SAFETY BULLETIN

Communication #: T-18-01

Model Year(s): 2015-2018

SUBJECT: SEAT BASE FRAME INSPECTION / REPLACEMENT

Passenger-Side Seat Base Frame Weld Inspection:

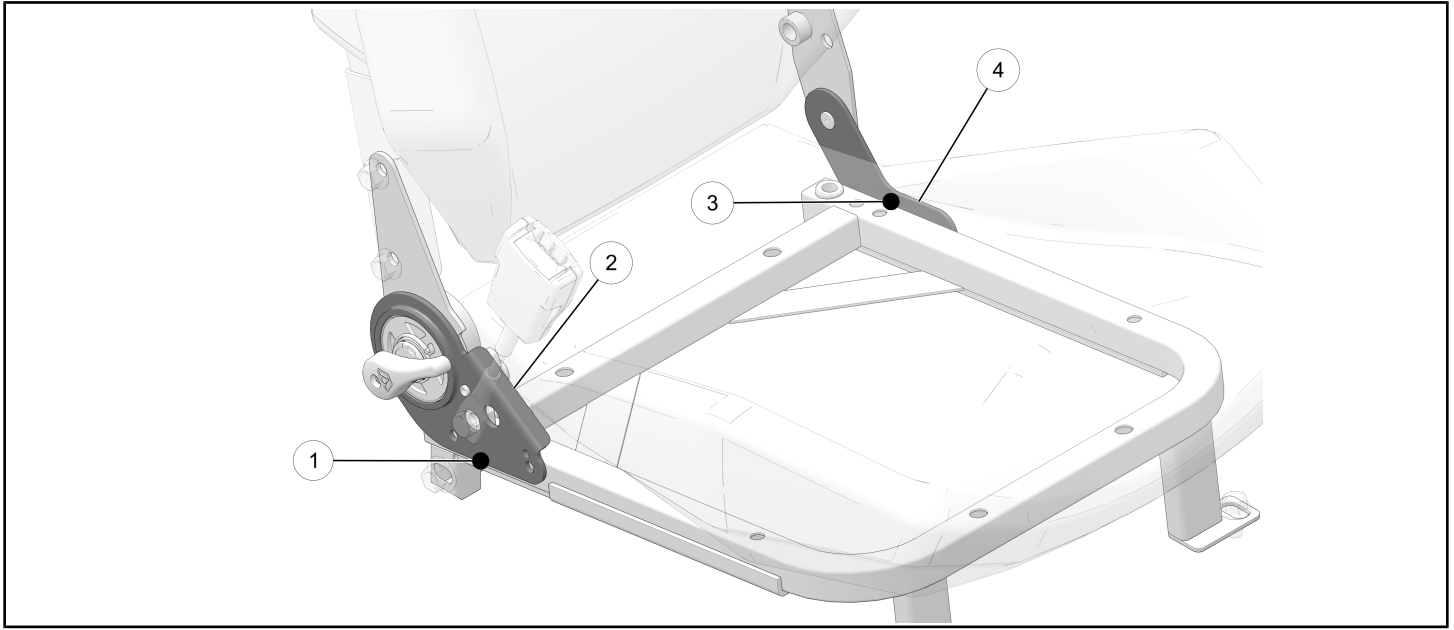
Each weld is unique, the length and size of the welds are not critical. If welds are present in the approximate locations specified, then the seat base frame passes inspection.

Visually inspect the passenger-side seat base frame using an inspection mirror and a flashlight at the locations shown below. See next page for examples of good and bad welds with locations matching the callout numbers ① - ④ below.

Welds must be present at all seat base frame locations. See next page for examples. If welds are missing, the seat MUST BE REPLACED.

| # | EXAMPLES OF GOOD WELDS | EXAMPLES OF MISSING WELDS |

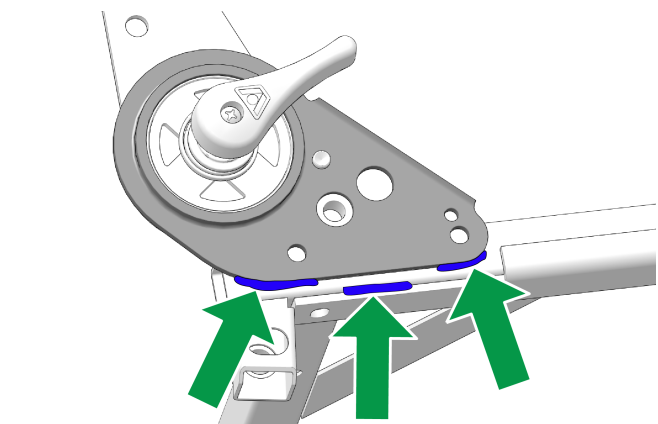
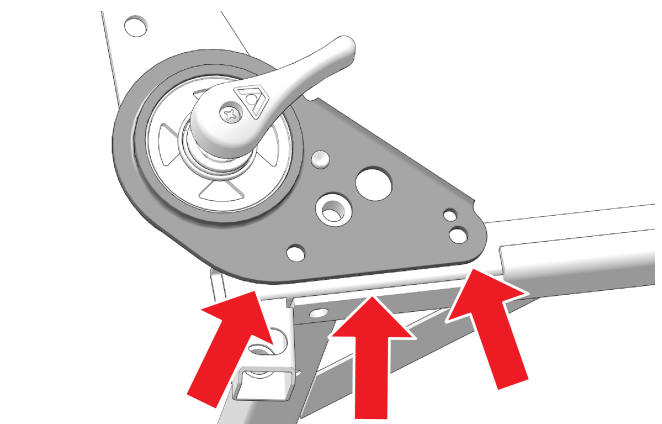
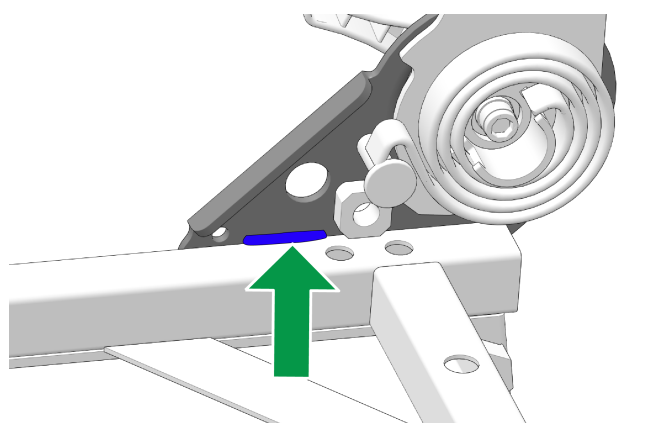
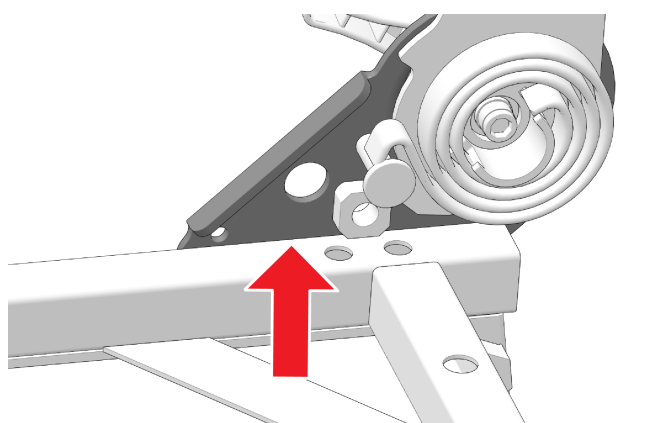
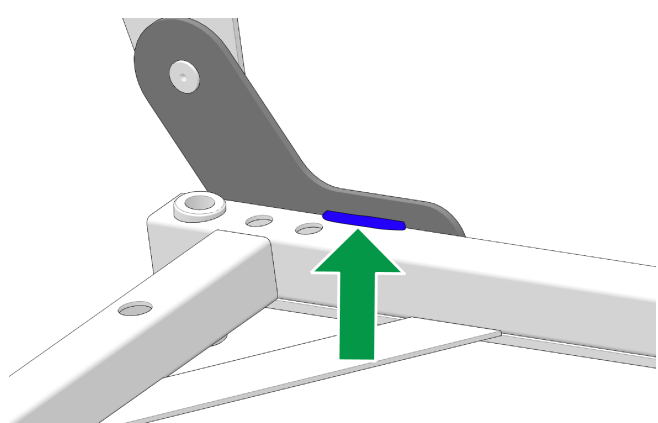
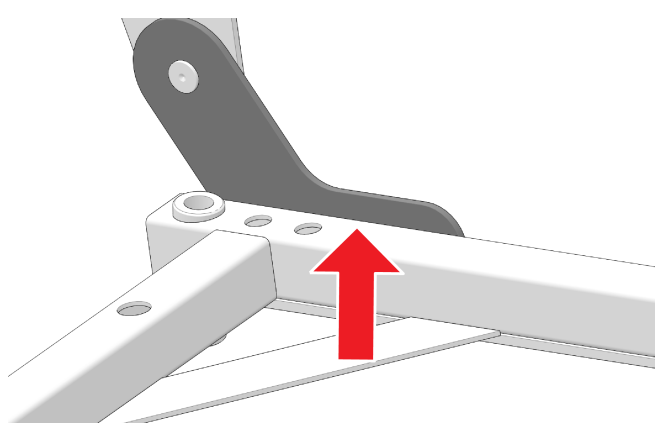
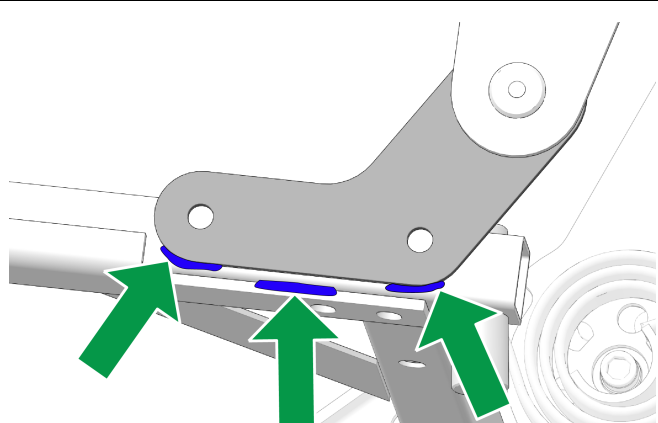
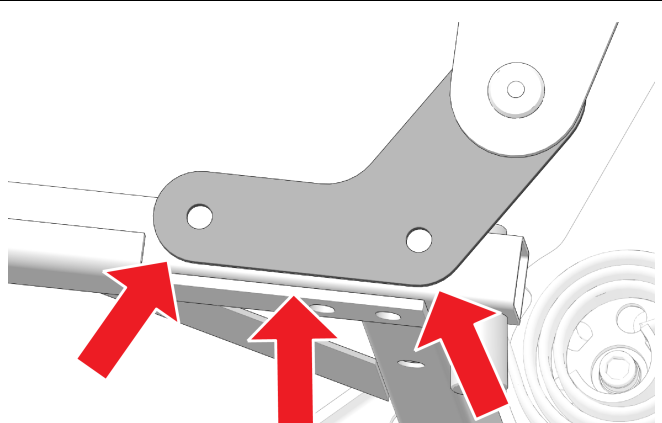
| # | EXAMPLES OF GOOD WELDS | EXAMPLES OF MISSING WELDS |
|---|--|---|
| ① |  <p>Diagram 1 shows a close-up of a metal bracket attached to a frame. Three green arrows point to three distinct, continuous weld lines along the bottom edge of the bracket, indicating proper welding.</p> |  <p>Diagram 1 shows the same metal bracket. Three red arrows point to gaps between the bracket and the frame, indicating missing welds.</p> |
| ② |  <p>Diagram 2 shows a different angle of the metal bracket. A single green arrow points to a continuous weld line, indicating a good weld.</p> |  <p>Diagram 2 shows the same angle. A single red arrow points to a gap between the bracket and the frame, indicating a missing weld.</p> |
| ③ |  <p>Diagram 3 shows another angle of the metal bracket. A single green arrow points to a continuous weld line, indicating a good weld.</p> |  <p>Diagram 3 shows the same angle. A single red arrow points to a gap between the bracket and the frame, indicating a missing weld.</p> |
| ④ |  <p>Diagram 4 shows a close-up of the metal bracket's bottom edge. Three green arrows point to three distinct, continuous weld lines, indicating proper welding.</p> |  <p>Diagram 4 shows the same close-up. Three red arrows point to gaps between the bracket and the frame, indicating missing welds.</p> |

Driver-Side Seat Base Frame Weld Inspection:

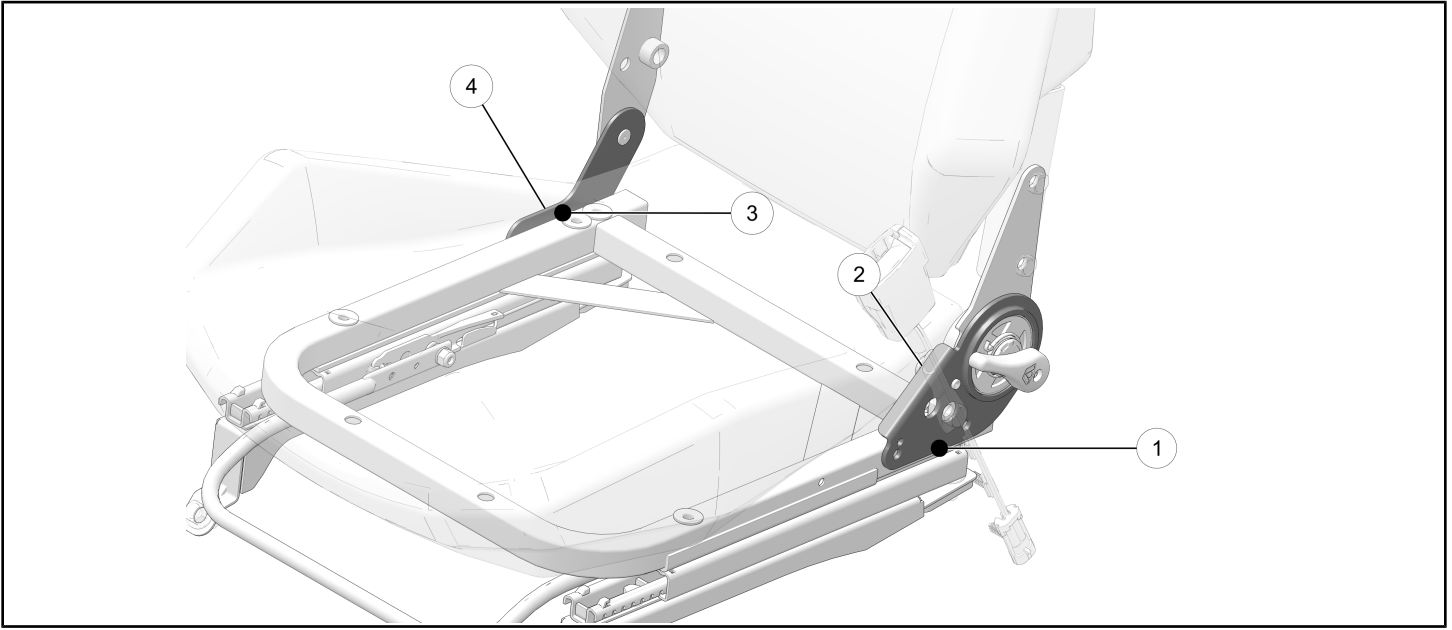
Each weld is unique, the length and size of the welds are not critical. If welds are present in the approximate locations specified, then the seat base frame passes inspection.

Visually inspect the driver-side seat base frame using an inspection mirror and a flashlight at the locations shown below. See next page for examples of good and bad welds with locations matching the callout numbers ① - ④ below.

Welds must be present at all seat base frame locations. See next page for examples. If welds are missing, the seat MUST BE REPLACED.

T-18-01-A SEAT SLIDER TEST

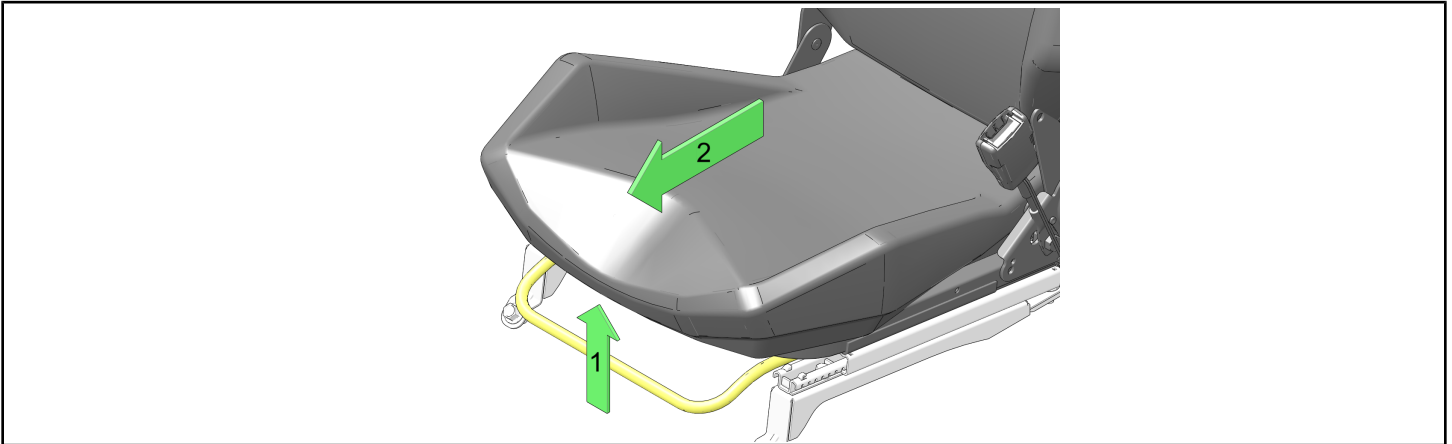
If the seat unlatches or moves more than one tooth rearward in ANY of the four positions, the test is considered a FAIL and a new seat base MUST be installed:

- **If the seat passes both the Seat Base Frame Weld Inspections, page 6, and Seat Slider Test on page 11, then no seat base replacement is required. File a claim for T-18-01-A.**
